ASB-1001

Service Bulletin

Subject: TS-950SDX Distorted DRU-2 TX Audio **Date:** November 4,

Subject: TS-950SDX Distorted DRU-2 TX Audio **Date:** November 4,

MIC AMP (X59-3710-01)

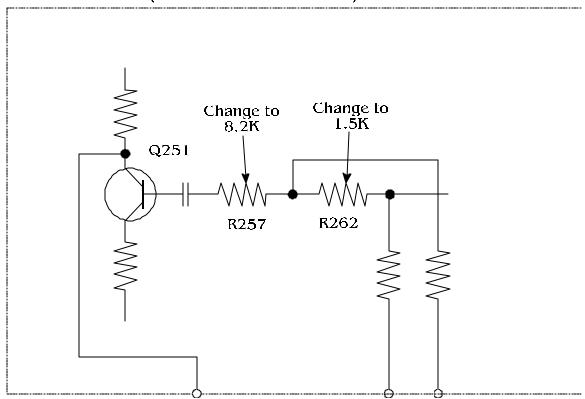
Cause: This characteristic is caused by an impedance mismatch between the DRU-2 output and the input of the microphone amplifier circuit in the TS-950SDX. The following modification will correct/improve this characteristic.

On the Microphone Amplifier Unit (X59-3710-01), which is part of Switch Unit (A) (X41-3240-00) (H/10): (The Microphone Amplifier Unit is a small daughter board located on the switch assembly that has the Microphone Gain/Power Output Control and the Speech Processor IN/OUT controls.

- 1. Change chip resistor R257 from 4.7K to 8.2K ohms (RK73FB2A822J).
- 2. Change chip resistor R262 from 4.7K to 1.5K ohms (RK73FB2A152J).
